Cook Shire Council

Webber Esplanade

Rock Revetment Review

April 2016

Photo 15

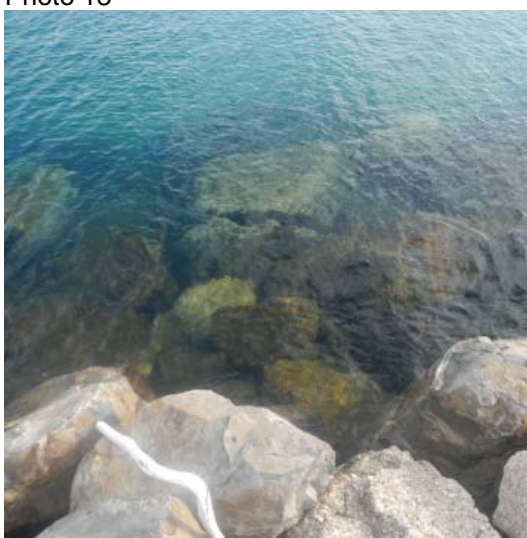
1.	<p>Toe rock has been placed on the seabed, generally 2 to 3 rocks in length, and sized generally in accordance with the amended approved drawing CSC-C002 rev 0. See photo 15 below, in particular.</p> <p>The toe rock generally exceeds the specified D_{n50} 900 mm, typically ranging from 1 to 2 metres in diameter.</p>	Yes, based on an assumed rock density of 2.6 t/m^3	Yes, toe rock provides allowance for scour.

Photo 36

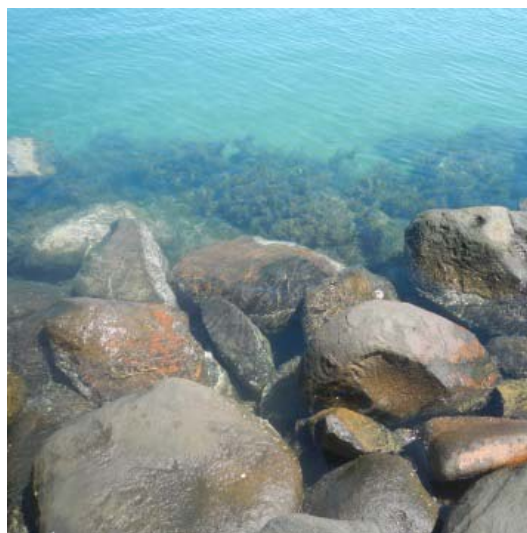
1.	<p>Toe rock has been placed, generally 2 to 3 rocks in length, and sized generally in accordance with the amended approved drawing CSC-C002 rev 0. See photos 36 and 37 below.</p> <p>The toe rock generally exceeds the specified D_{n50} 900 mm, typically ranging from 1 to 2 metres in diameter.</p>	Yes, based on an assumed rock density of 2.6 t/m ³	Yes, toe rock provides allowance for scour.

Figure 3 Typical amended approved revetment section (drawing no. CSC-C002)

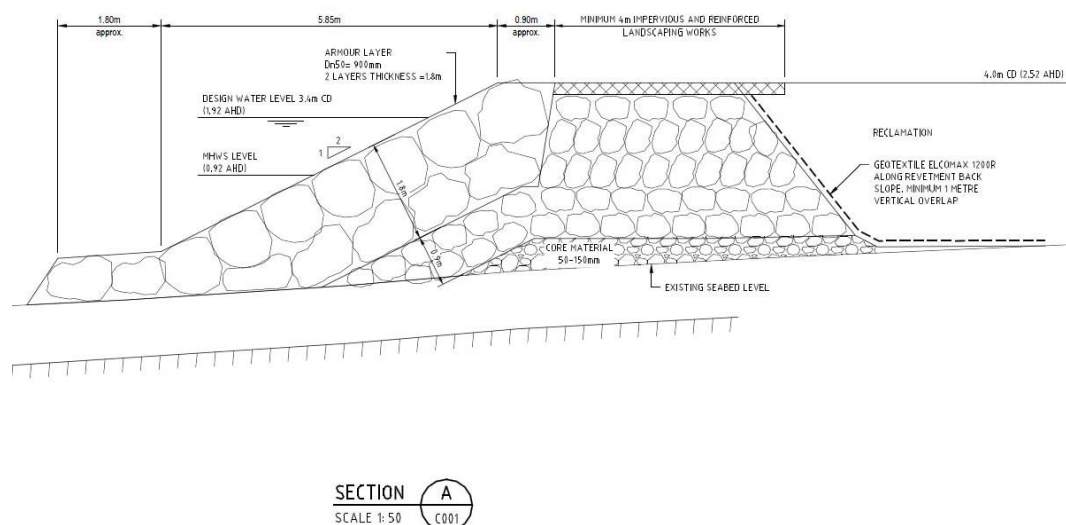
In summary, 'peel back' test pits numbered 1, 2, 3 and 5 generally provided a consistency of results, thereby providing a basis to draw appropriate conclusions and recommendations. In particular, the following defects were consistently evident within all 'peel backs', contrary to both the amended and approved CSC drawings (see Figure 3 for typical section) and EHP's operational policy, building and engineering standards for tidal works;

- The armour layer grading is too widely graded and outside typical static revetment grading specification. Undersized rock armour leads to unacceptable safety and performance risk.

- The armour layer porosity is too high, with poor interlocking evident, most likely due to poor placement techniques during construction. High porosity within the armour layer leads to unacceptable safety and performance risk.

- The underlayer is too widely graded and outside typical static revetment grading specification. It is most likely that the underlayer material was end dumped by truck tipper during construction, which is unacceptable practice for static revetment build within a marine environment.

- There is a high fines content in the core material leading to a high risk of fine material leaching out of the structure and reclamation over time. Leaching of fill material is likely to lead to settlement risk and further deterioration of the revetment and adjacent landside infrastructure. Further sampling and testing of both the core and rock armour would be required in order to confirm particle size distribution and rock grading curves to further assess and define the risk of high fines content release.
